802.1ASdm

Hot Standby Split function

Comment #34 against D0.5

IEEE 802.1 TSN

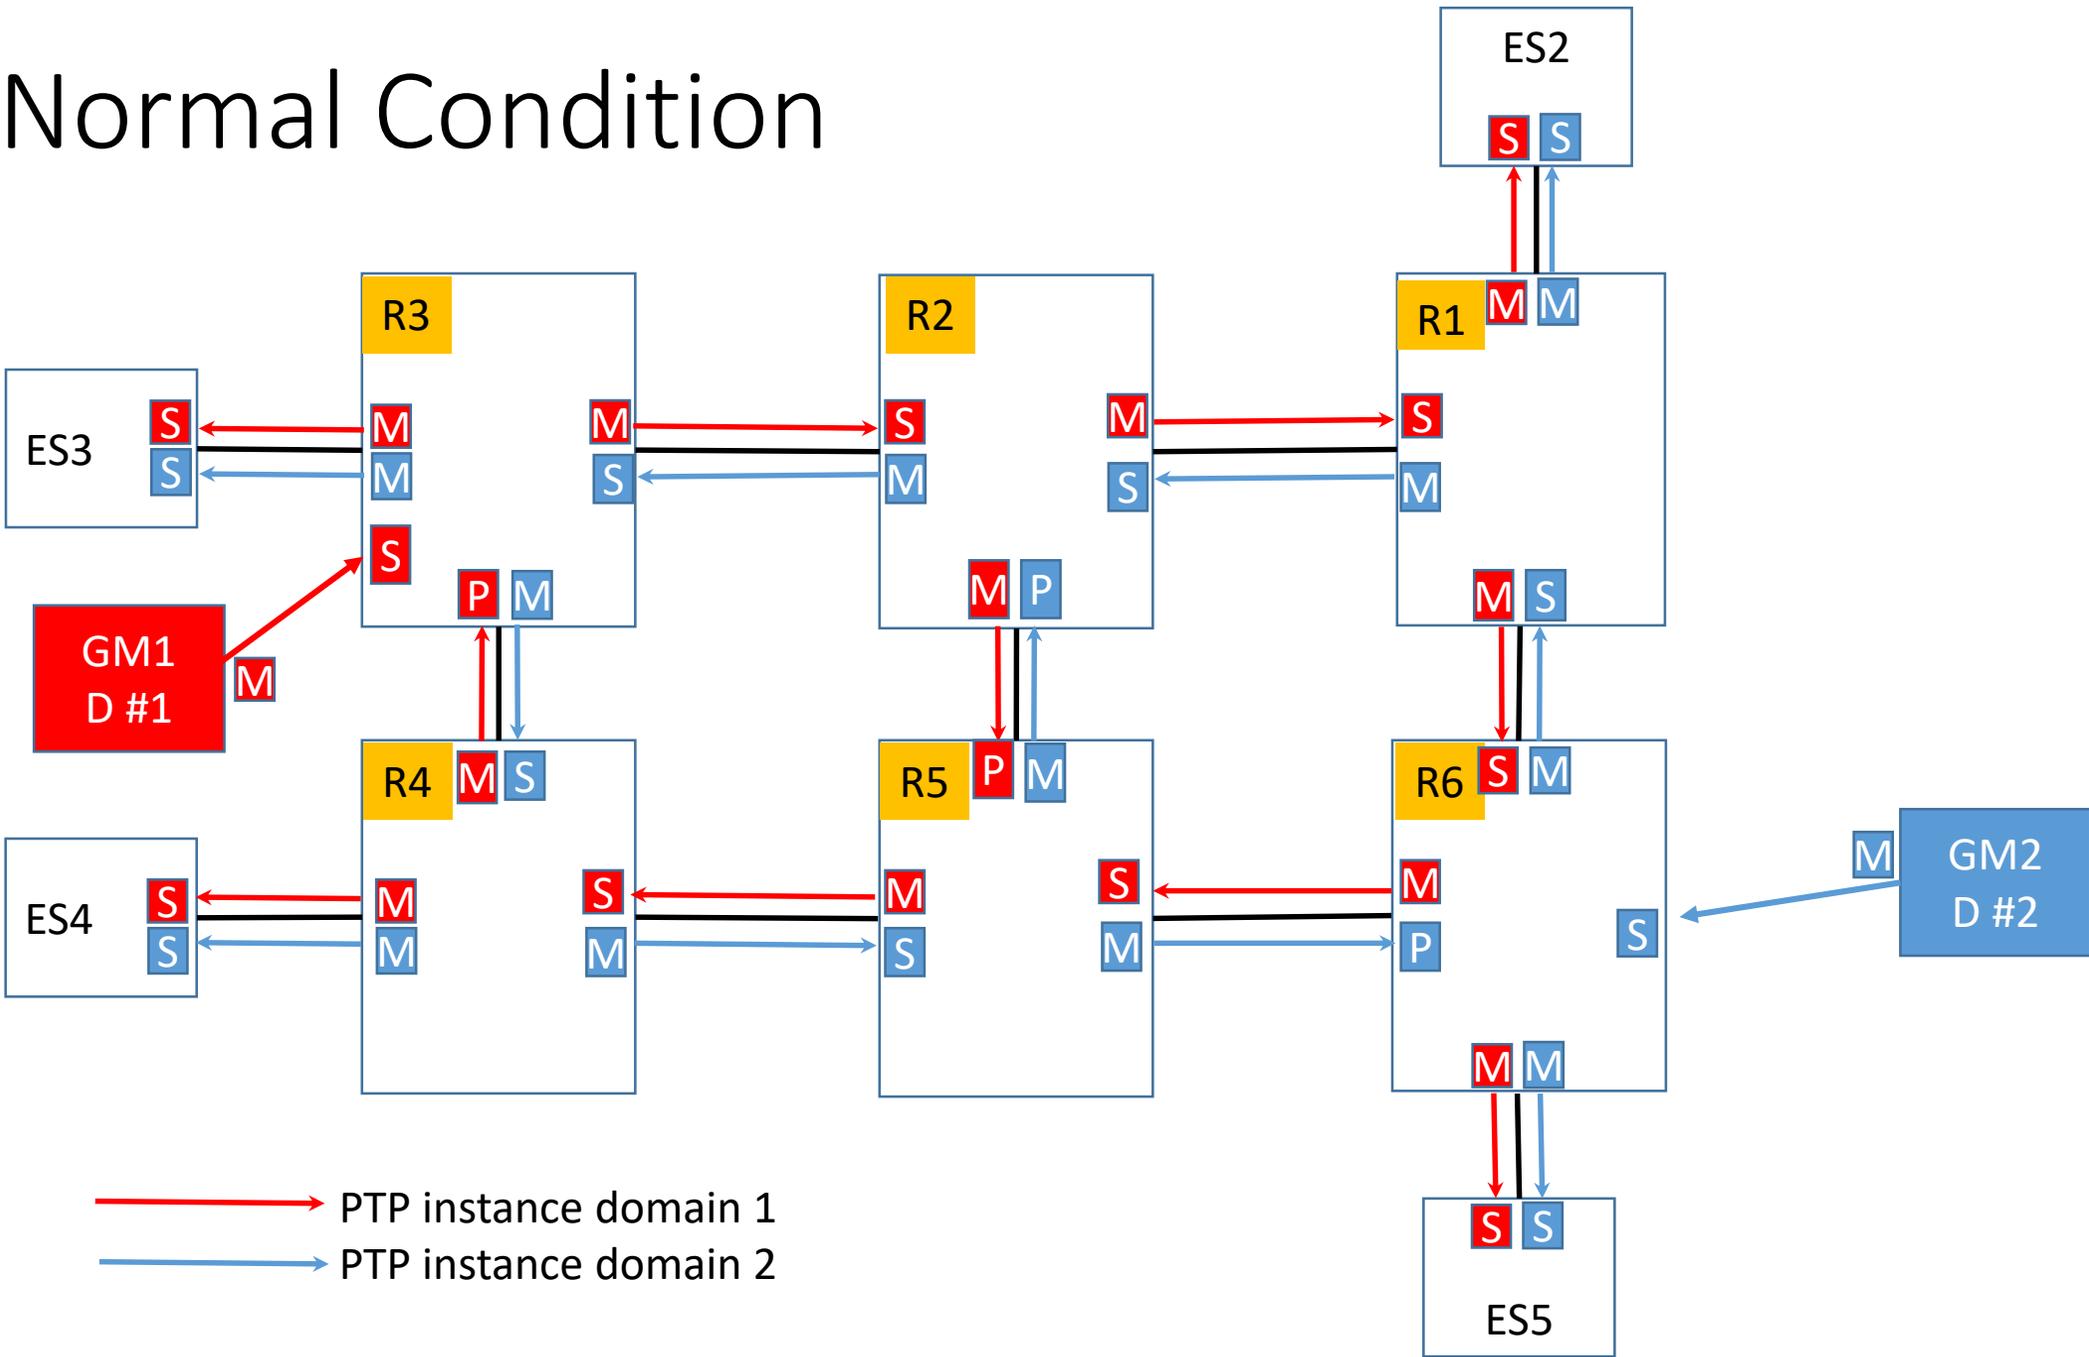
Don't we need to also take into consideration the transfer of time sync from the secondary to the primary?

The reason for the Editor to not consider this case was described in NOTE 2 in the next page.

The commenter thinks that it is important to consider this case, and if there is interest from the group, then the commenter can bring a contribution to further develop the technical details on this.

If the group agrees the commenter will bring a contribution to address this case.

ACCEPT IN PRINCIPLE. Add an editor's note requesting contributions on this topic. Incorporate the results of the discussion of submitted contribution(s).

GM2 and GM1 Failure – Avoid timing loop – solution 1

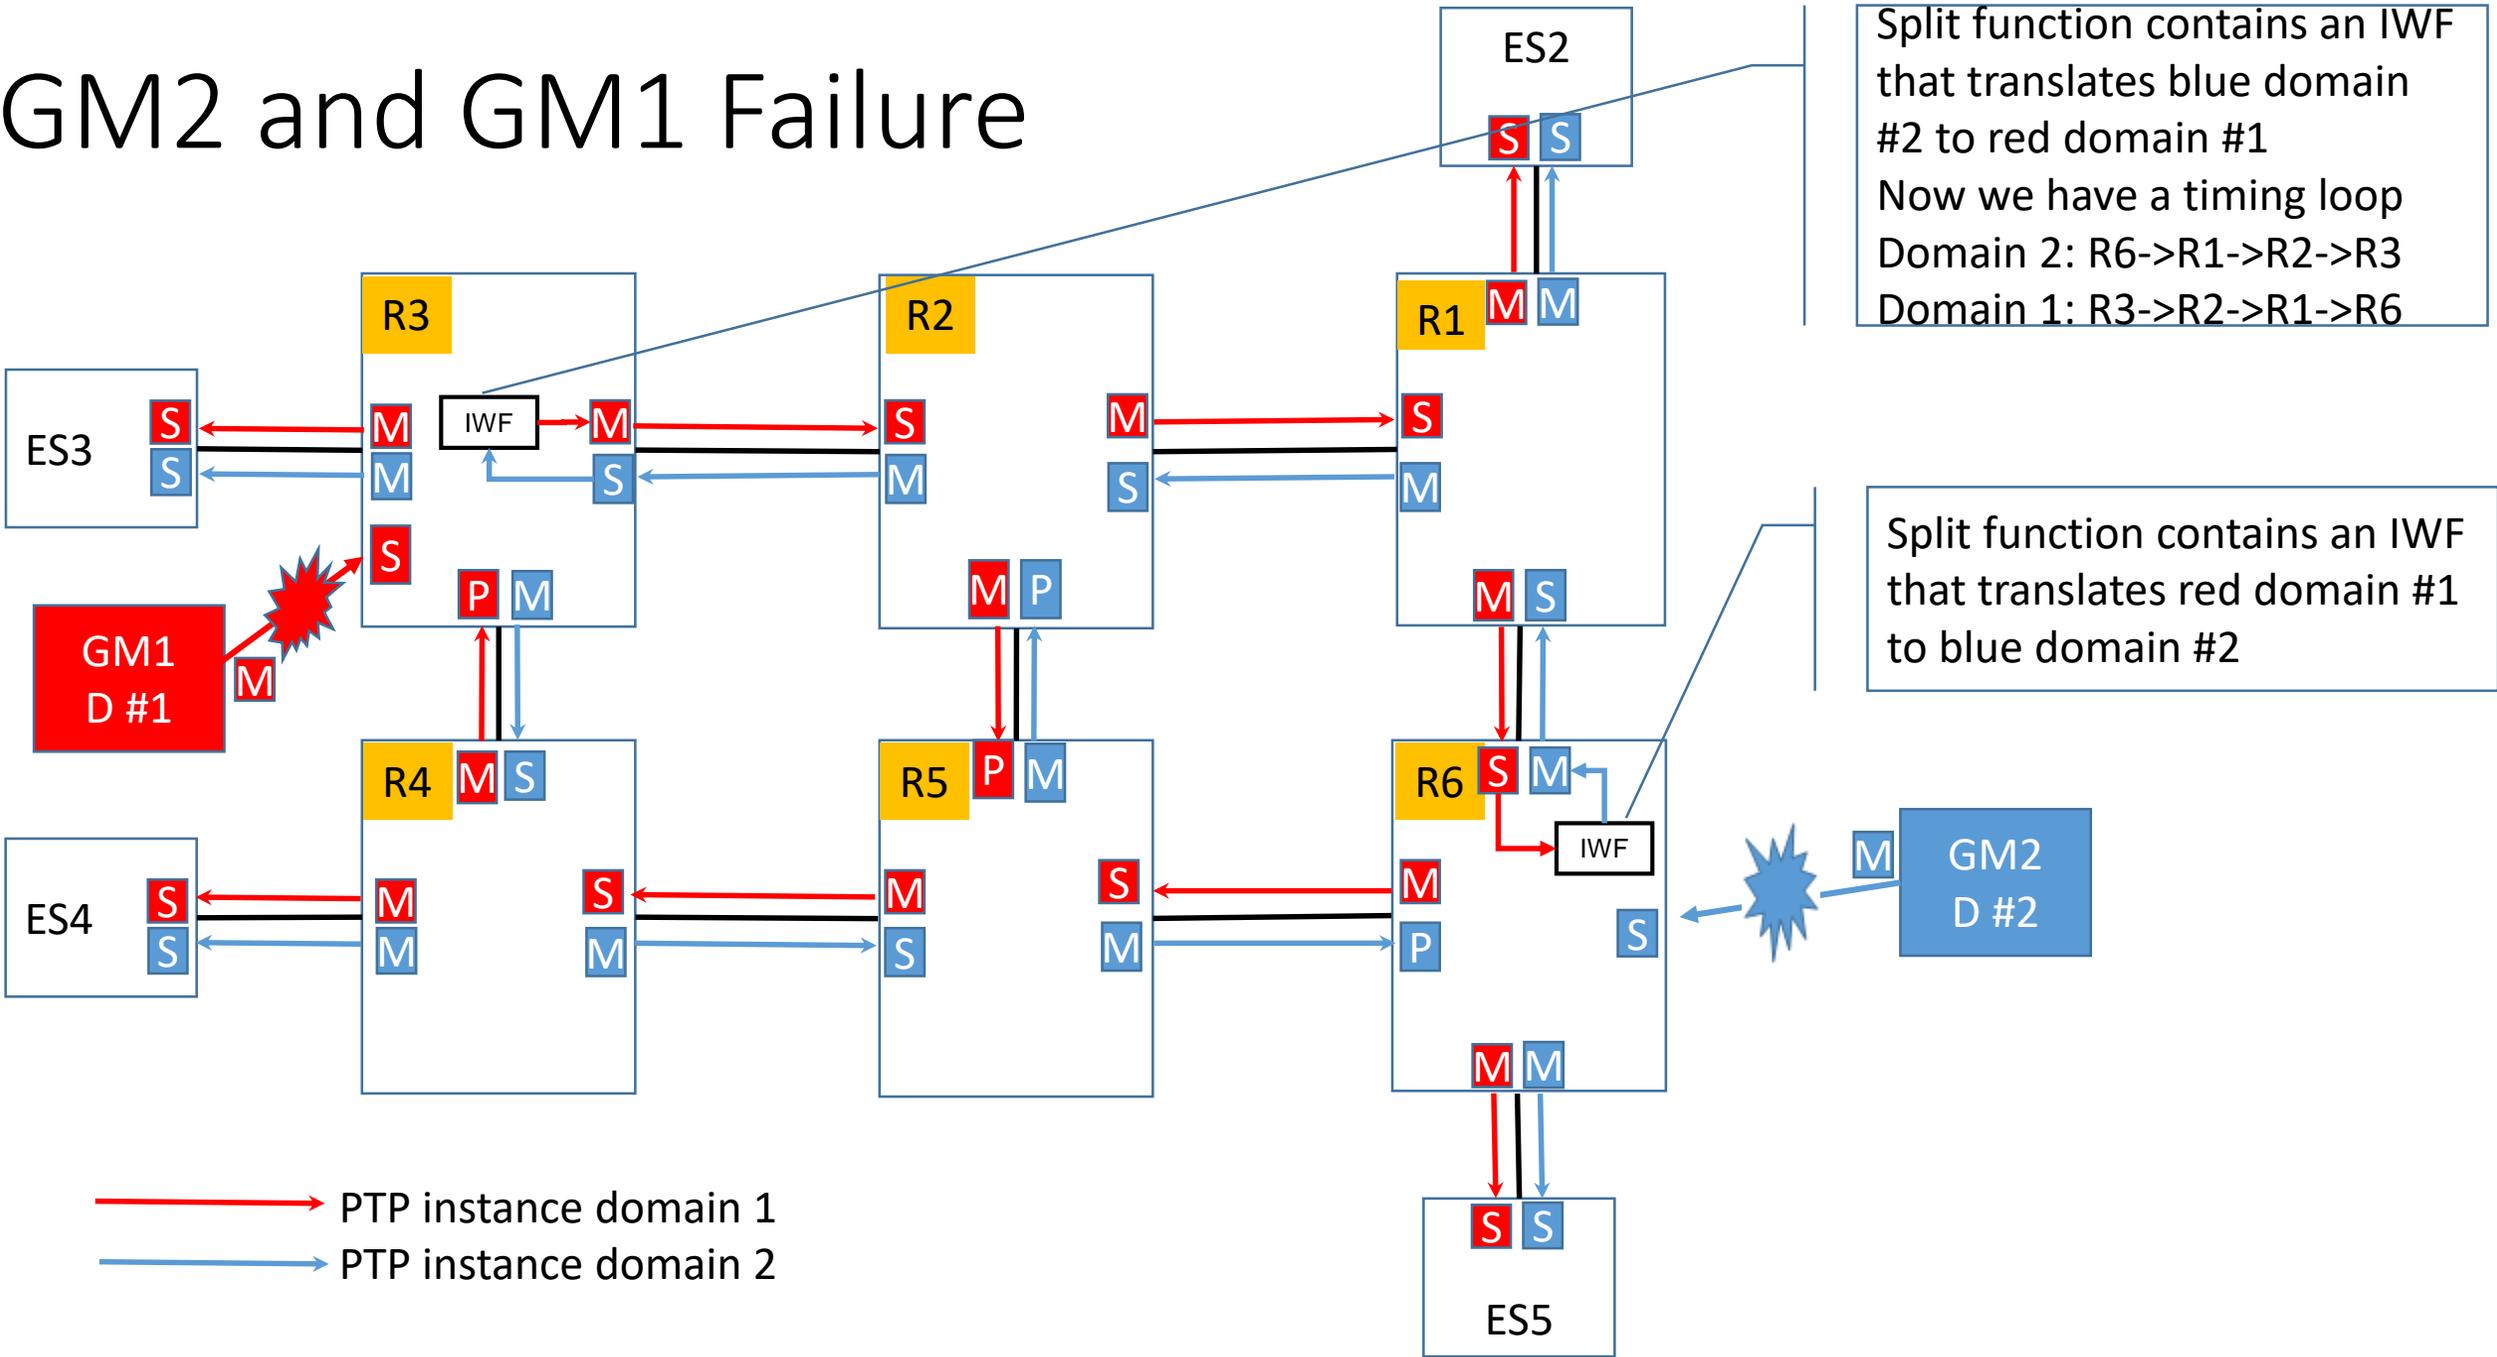
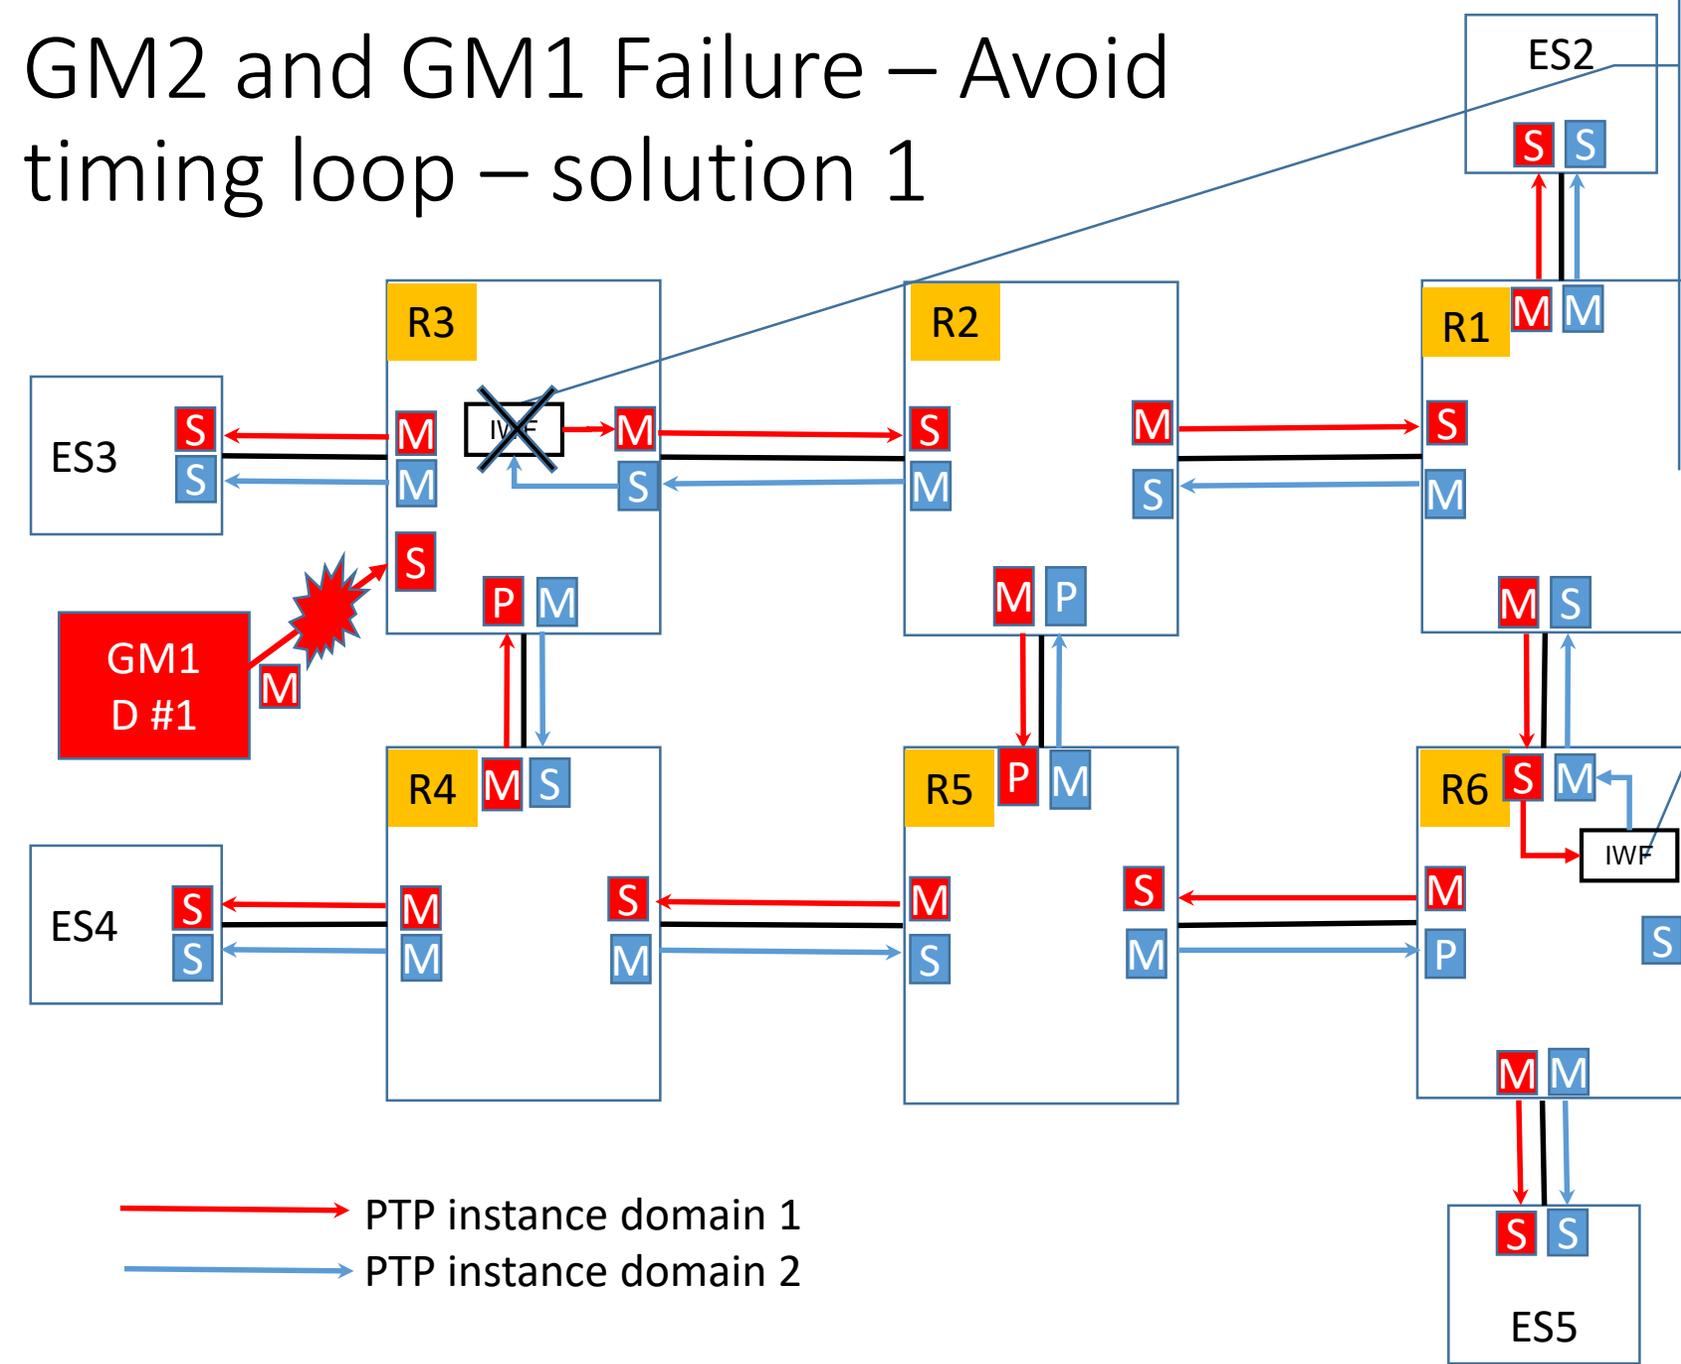
When GM1 fails, R3 knows that it should not activate the IWF as Domain 2 was using the time from Domain 1, **because it does not receive Announce message from the GM of Domain 2**, and therefore this information can be used to avoid the timing loop.

When GM2 fails, the domain 2 message is translated from domain 1 at R6.
